AGENDA TECHNICAL REVIEW COMMITTEE DECEMBER 6, 2022 10:00AM

A. <u>Park Square Fruitland Park – Annexation, Rezoning & Small Scale Comp Plan</u> <u>Amendment (SSCPA) - Alternate Keys: 1289691</u>

B. Crystal Lake Vista – Preliminary Plan/Plat (Alternate Key: 1288606)

CITY OF FRUITLAND PARK STAFF REPORT BY LPG URBAN & REGIONAL PLANNERS, INC.

C-2.1

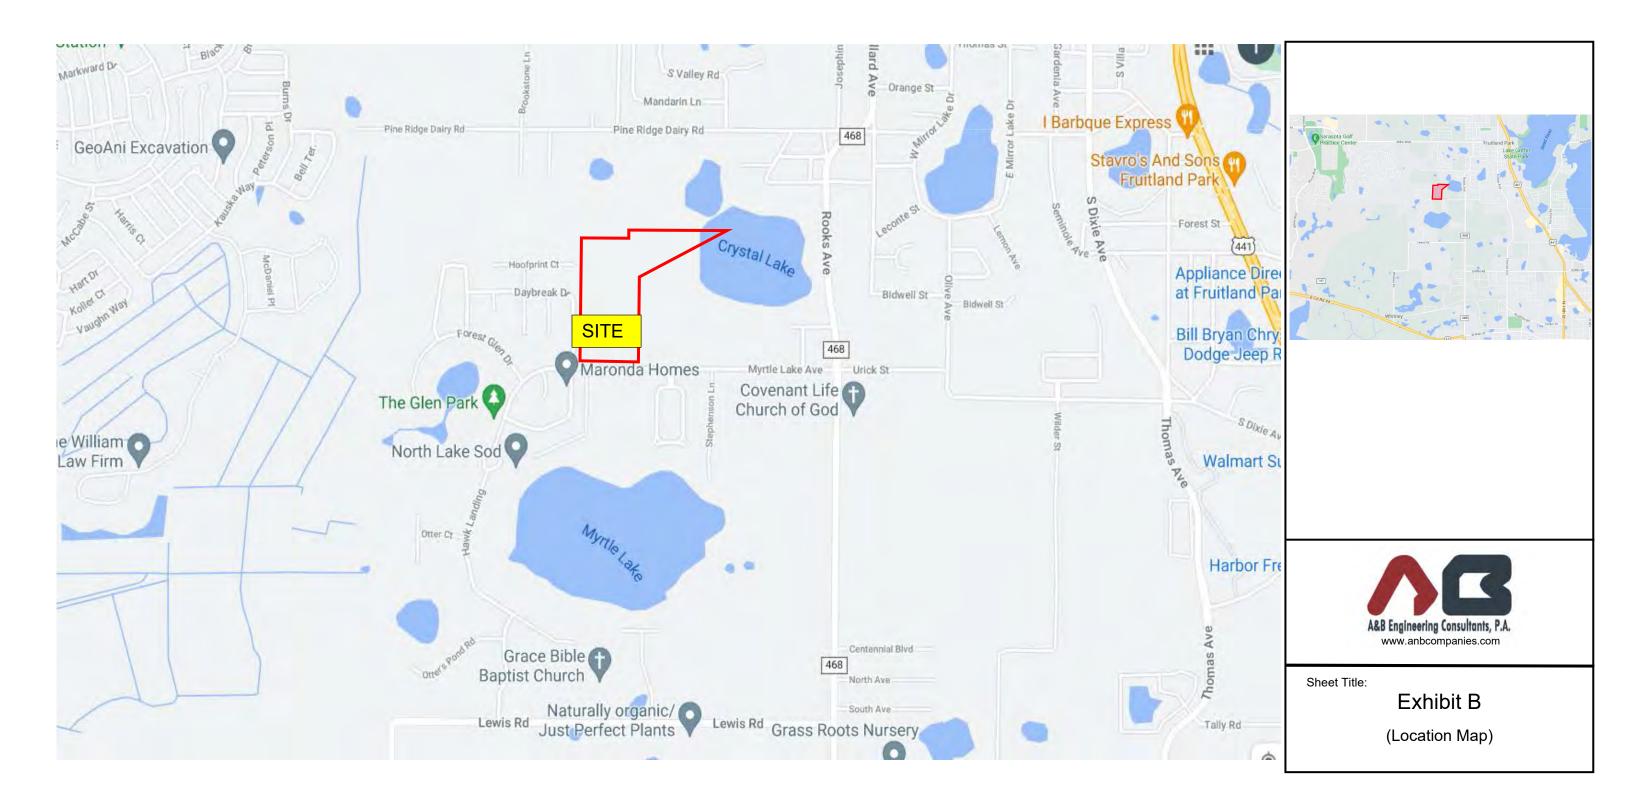
The applicant has addressed all outstanding planning issues with the final determination regarding tree removal to be addressed by the City Commission.

Planning staff recommends approval of the preliminary plat subject to City legal counsel approval, engineering approval and subject to City Commission approval of the proposed tree removal permit.
